Project	IEEE 802.16 Broadband Wireless Access Working Group < http://ieee802.org/16 >	
Title	Space-frequency bit-interleaved coded modulation for MIMO-OFDM/OFDMA systems	
Date Submitted	2005-01-26	
Source(s)	Sumeet Sandhu, Nageen Himayat, Shilpa Talwar, David Cheung, Qinghua Li, Yuval Lomnitz, Wendy Wong, Uri Perlmutter, Yang-seok Choi, Eddie Lin Intel Corporation	sumeet.sandhu@intel.com Voice: +1-408-765-8558
Re:		
Abstract	<p>Draft 802.16e/D5a contains references references to horizontal and vertical encoding architectures <u>as means to map spatially multiplexed schemes to multiple antennas. However, the exact details of the mapping are not specified. Interleaving of spatial streams across antennas is important to achieve spatial diversity for MIMO systems.</u> for MIMO. Starting on page 362, the vertical encoder proposed for spatially-multiplexed MIMO systems does not specify details of the blocks shown in Figure 251c, i.e. the Encoder, Modulation, Demux and Sub-carrier mapping/PRBS blocks. It is important to design these blocks carefully to fully exploit spatial and frequency diversity with all types of receivers.</p> <p>In this contribution we propose space-frequency bit-inte

Figure 4xxx: Space-frequency bit-interleaved coded modulation (SF-BICM)

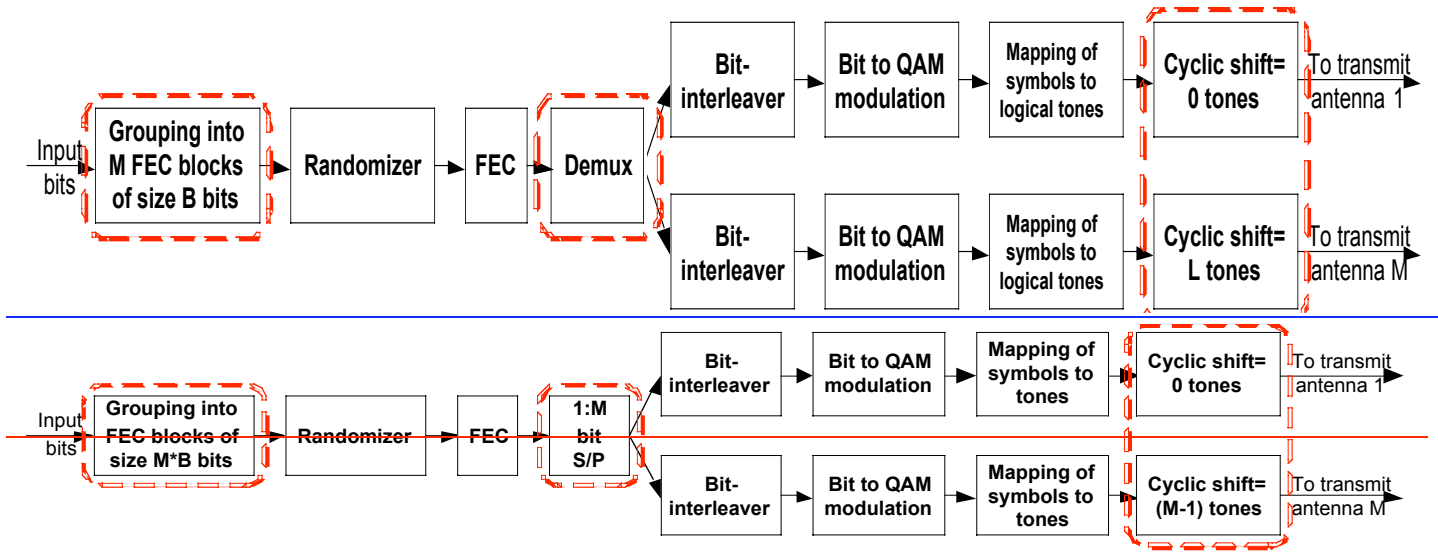
[This section describes 4 steps for mapping bits to multiple spatial streams and tones for convolutionally encoded MIMO. The key changes are steps 1, 2 and 4, and are circled in red in the figure below.](#)

- 1) **FEC encoding:** The incoming uncoded bits are grouped into M blocks of size MB and encoded with the usual convolutional code and punctured. The coded output blocks are of size MN_{CBPS} .

- 2) **Serial to parallel multiplexing (Demux):** The demultiplexer extracts bits for the chains one by one from its input bit sequence. The bits to the chain with higher modulation order are extracted before those with lower modulation order. Denote the number of bits per subcarrier on the m -th chain as L_m , where $L_1 \geq L_2 \geq \dots \geq L_M$. The demultiplexer first extracts the bits for the chain with the greatest modulation order as follows. The i -th extracted

- 3) **802.16e interleaving and tone mapping:** The resulting groups of N_{CBPS} bits on each spatial stream are interleaved according to the 802.16e interleaver and Gray mapped to QAM symbols. The resulting QAM symbols are mapped to N_{DS} logical tones according to 802.16e sub-channelization and tone-mapping. The same set of tones is occupied on each spatial stream.
- 4) **Cyclic tone shift:** The final step consists of cyclically shifting the symbol sequence mapped to the m^{th} spatial stream by $L = (m-1) \cdot (N_U/M)$ tones to the right.

Figure 3: Proposed SF-BICM mapping of bits to multiple antennas (or spatial streams)

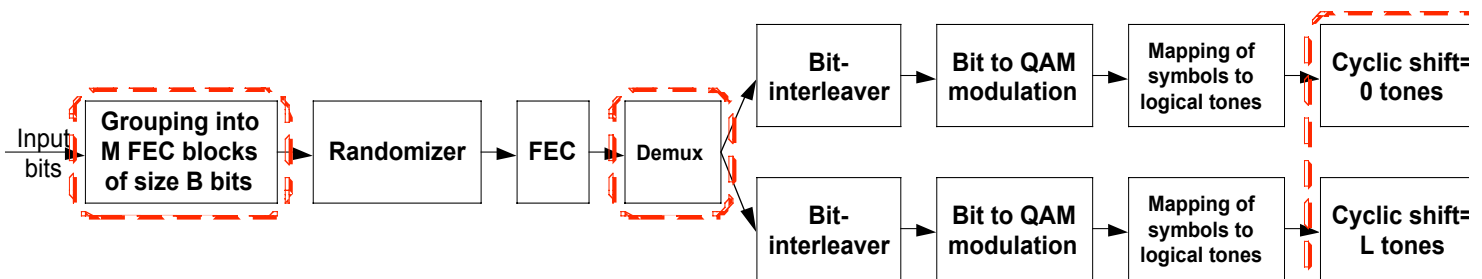
The proposed modifications to the existing 802.16e bit-to-tone mapping are steps 1, 2 and 4 as circled in red below.

- 1) **FEC encoding:** Group the incoming uncoded bits into M blocks of size MB , such that the coded output blocks are of size MN_{CBPS} . It is important to create larger FEC blocks to preserve frequency diversity going from SISO to MIMO systems. If the FEC block size were held constant and N_{CBPS} bits were mapped to $1/M$ of the SISO tones on M antennas, spreading across fewer tones on each antenna will not

- 2) **Serial to parallel antenna multiplexing (Demux):** The demultiplexer extracts bits for the chains one by one from its input bit sequence. The bits to the chain with higher modulation order are extracted before those with lower modulation order. Denote the number of bits per subcarrier on the m -th chain as L_m , where $L_1 \geq L_2 \geq \dots \geq L_M$. The demultiplexer first extracts the bits for the chain with the greatest modulation order as follows. The i -th

- 2)3) ~~Coded bits are serial to parallel multiplexed to different antennas. The bits indexed by $m:M:MN_{CBPS}$ are mapped to the m^{th} antenna.~~

- 3)4) **802.16e interleaving, modulation and tone mapping:** The resulting groups of N_{CBPS} bits on each antenna are interleaved according to the 802.16e interleaver and Gray mapped to QAM symbols. The resulting QAM symbols are mapped to logical tones in the assigned 802.16e sub-channels.

- 4)5) **Cyclic tone shift:** The final step consists of introducing a cyclic shift of $L = (m-1) \cdot (N_U/M)$ tones ~~$m-1$ tones~~ to the symbol sequence mapped to the m^{th} antenna. This ensures that adjacent coded bits aren't mapped to the same tone on different antennas. If adjacent coded bits get mapped to the same tone on different antennas, an MMSE receiver correlates the noise on all these bits thus degrading performance. Placing adjacent coded bits on different tones on different antennas de-correlates noise on adjacent bits, thus improving performance and providing greater spatial diversity.

- a) Note that the amount of cyclic shift ~~may be greater than 1 tone from antenna to antenna~~ is set to the maximal value in this case, although a shift of 1 works well in most cases. In general, the optimum cyclic shift must be determined by simulation for different rates and MIMO configurations. The maximum cyclic shift is equal to $N_{DS} - N_U / M$, where N_{UDS} = number of data tones ~~that 1 FEC block is mapped to assigned to a user~~.
